**REGULAR MEETING
OF THE VINEYARD PLANNING COMMISSION,
Wednesday, February 17, 2021 at 6:00 p.m.**

Date: February 17, 2021
 From: Morgan Brim, Community Development Director
 To: Planning Commission
 Item: Central Utah Water Conservancy District Well Site 17, Conditional Use Permit
 Address: 349 North Geneva Road, Vineyard, Utah
 Applicant: Shaun Hilton, Project Engineer, Central Utah Water Conservancy District (CUWCD)
 Owner: Anderson Geneva, LLC

Item: Eastlake Lot 05, Site Plan

Sheet No.
C - 2.0

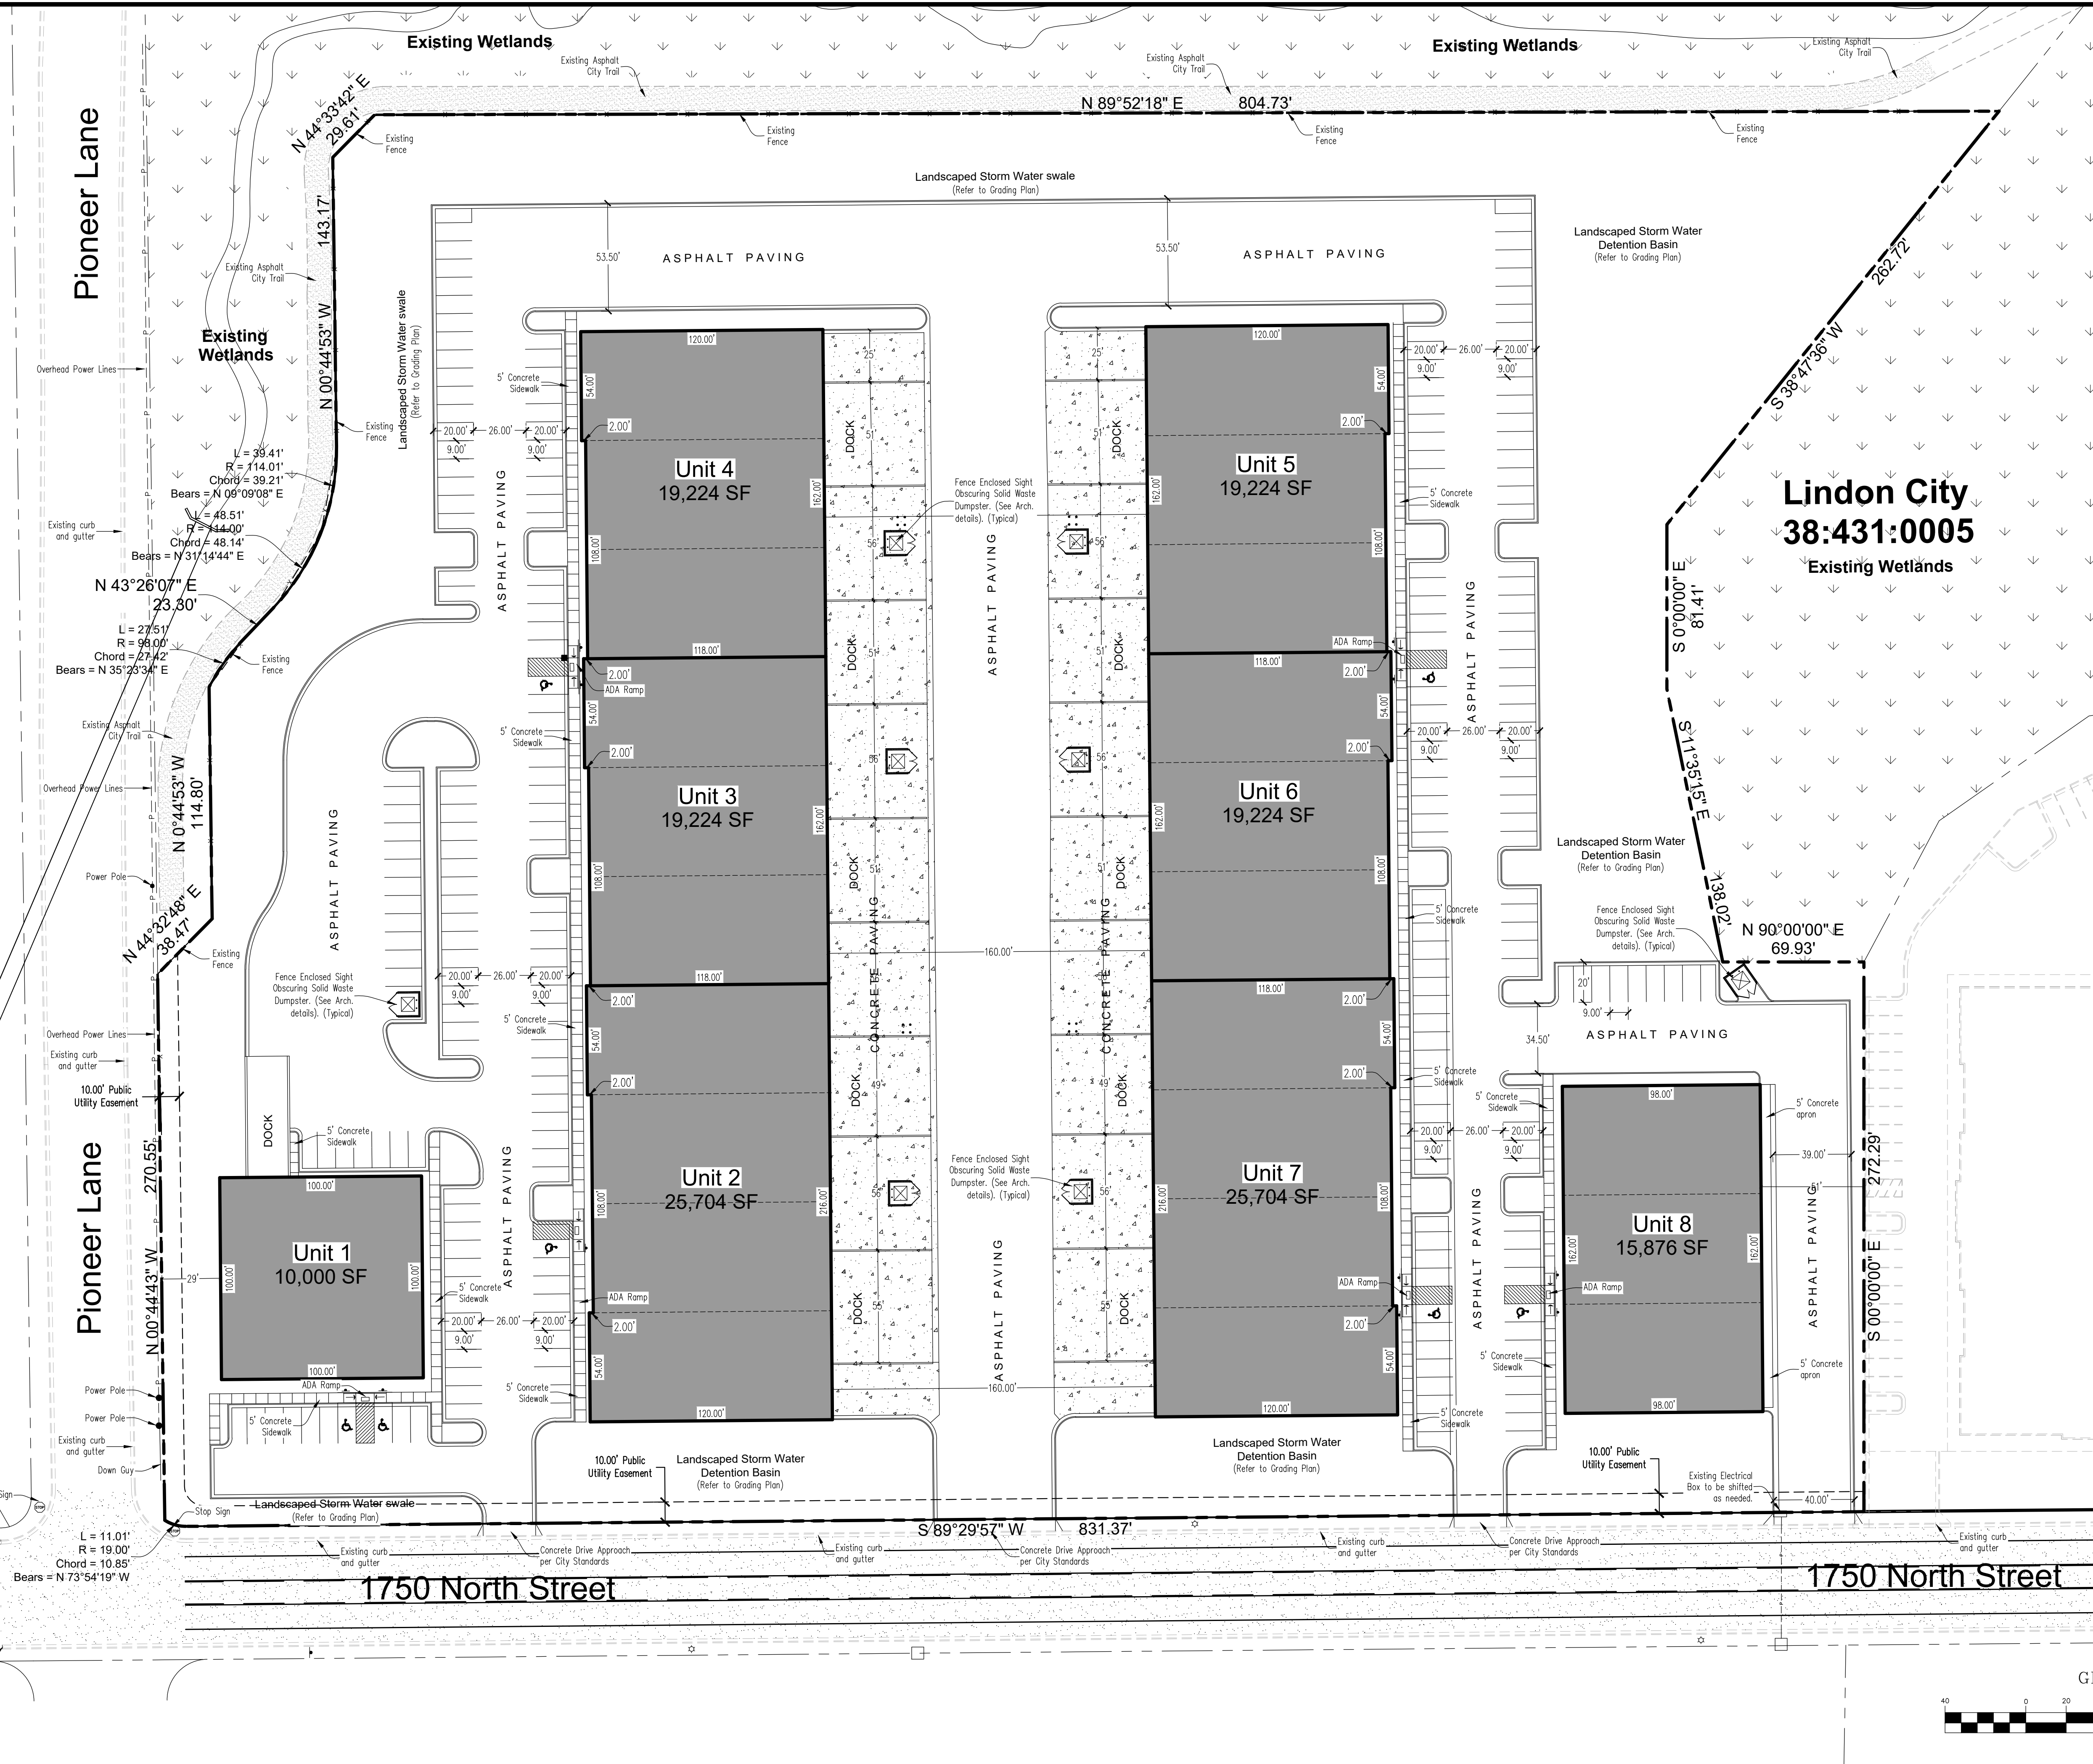
15.36.030.5.c Building Location	All project and building plans shall allow for, and provide interconnected streets, walkways, trails, and parking areas, as applicable	MSI Properties will take this into consideration adding a connection to the existing Lindon Heritage Trail on the north and west sides of their property. They will discuss this in further meetings.	☒ Yes ☐ No ☐ N/A

15.36.030.9 Subdivision and Site Design and Layout	All subdivision and site plans shall recognize and preserve, as much as practicable, the natural features and sensitive areas occurring on the site. All subdivisions and other projects shall demonstrate efficiencies in the provision of infrastructure, including reductions in hard-surfaced areas, land disturbance, and the retention of existing vegetation, as practicable	This site plan exceeds the minimum required amount of parking. Parking calculations have been provided: Manufacturing: 22 Warehouse: 125 Office Space: 75 Total Spaces Required: 222 Total Spaces Provided: 234 ADA Spaces Required: 7 ADA Spaces Provided: 8	☒ Yes ☐ No ☐ N/A

1. The applicant/owner shall provide screening of all parking lots of four (4) or more spaces visible from the street view by a landscaped berm, decorative wall, vertical landscaping, or combination thereof at least three (3) feet high, as measured from the finished grade

adjacent to the parking area to be screened (please see VZC 15.38.030.1.n. 'Screening').
The applicant shall clearly label such screening on a revised site plan.
